SERVICE BULLETIN

EL14-020

2013 – 2014 NV; SLIDING DOOR WILL NOT LOCK/UNLOCK WITH FOB OR DOOR SWITCHES

Figure 1

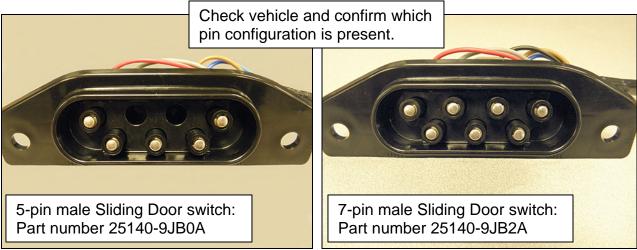
Replace the Sliding Door Switches (shown on page 2) with those listed in the Parts Information table.

NOTE: The door will use either the 5-pin or 7-pin Sliding Door Switch based on the vehicle options.

DESCRIPTION	PART #	QUANTITY
Sliding Door Switch (female)	25141-9JB0A (1)	1
Sliding Door Switch (male 5-pin)	25140-9JB0A (2)	1
Sliding Door Switch (male 7-pin)	25140-9JB2A (2)	I

(2) One male switch required per vehicle (see Figure 1 and Figure 2).
